Service Bulletin

Bulletin No.: PI0814C

Subject: Steering Shudder (Vibration) During Slow Speed Maneuvers

Models: 2010-2013 Chevrolet Equinox
2010-2013 GMC Terrain
Equipped with Engine RPO LF1, LFW or LFX

2900701

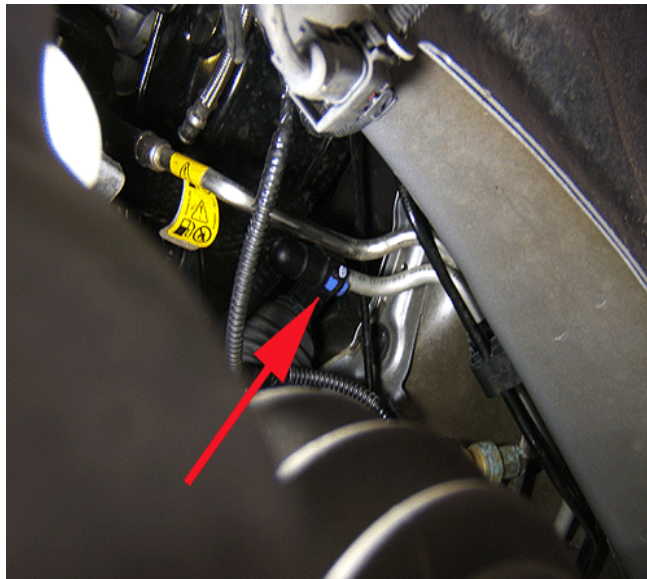
3.1. Disconnect the hose from the evaporative emission canister purge solenoid valve located by the base of the throttle body.

2900703

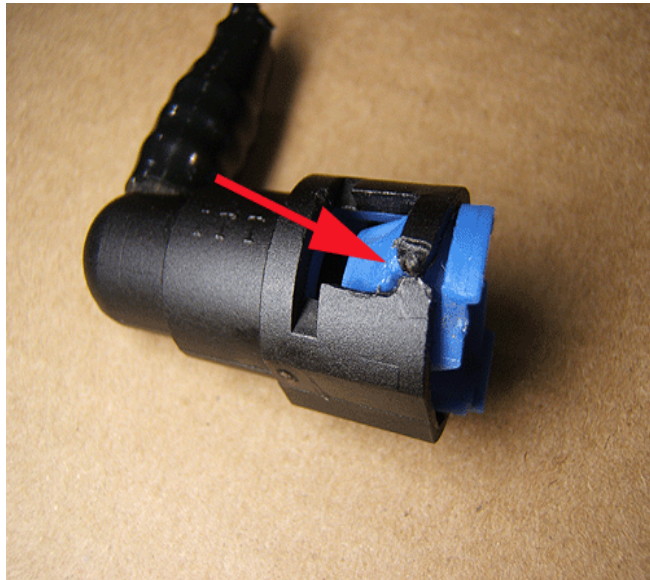
3.2. Disconnect the hose from the chassis to canister evaporative emission line.

2900708

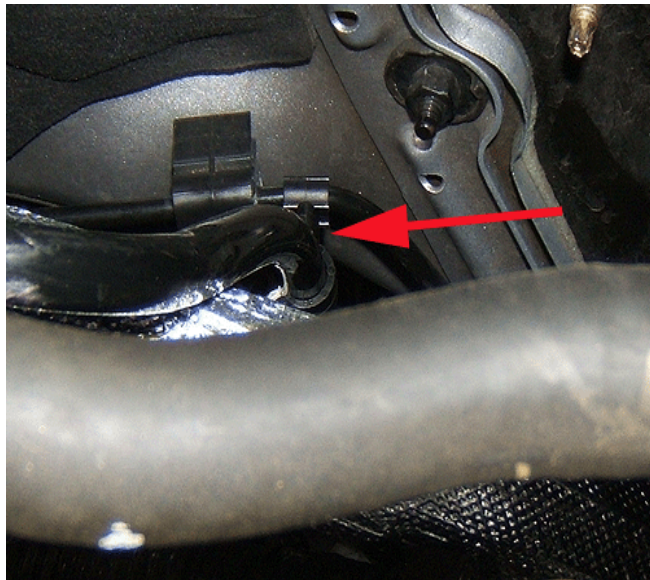
It may be necessary to cut the plastic connector on the hose if the blue plastic retention collar cannot be released. A new connector is part of the new hose assembly.

3.3. Remove the existing hose and install the new hose assembly.

Route the new hose in a way that avoids contact with chassis and body components. Connect both ends of the hose.
